Project	IEEE 802.16 Broadband Wireless Access Working Group < http://ieee802.org/16 >	
Title	Enhanced Idle Mode Operation	
Date Submitted	2004-05-17	
Source(s)	Hang Zhang, Mo-Han Fong, Peiyong Zhu, Wen Tong Nortel Networks 3500 Carling Avenue, Ottawa Ontario, Canada K2H 8E9	mhfong@nortelnetworks.com Voice: +1-613-765-8983 Fax: +1-613-765-6717
Re:	IEEE P802.16e/D2-2004	
Abstract	Enhanced Idle Mode operation to reduce MAC signaling overhead and enable fast transition	
Purpose	Adoption of proposed changes into P802.16e	
Notice	This document has been prepared to assist IEEE 802.16. It is offered as a basis for discussion and is not binding on the contributing individual(s) or organization(s). The material in this document is subject to change in form and content after further study. The contributor(s) reserve(s) the right to add, amend or withdraw material contained herein.	
Release	The contributor grants a free, irrevocable license to the IEEE to incorporate material contained in this contribution, and any modifications thereof, in the creation of an IEEE Standards publication; to copyright in the IEEE's name any IEEE Standards publication even though it may include portions of this c

Figure XX. Location Update header format.

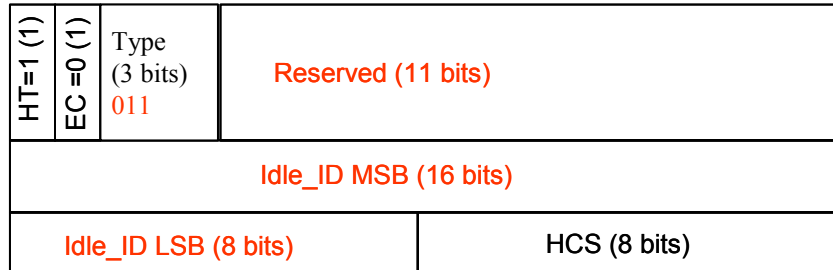
[Add Section 6.3.2.1. 4 to describe the location update (LU) MAC header format]

The location update PDU shall consist of location update (LU) header alone and shall not contain a payload. The location update header is illustrated in Figure XX.

The TYPE field shall be set as '011' to indicate that this is a location update header and no payload attached. Idle_ID field (24 bits) is the Idle_ID assigned to a MSS when the MSS enters Idle Mode.
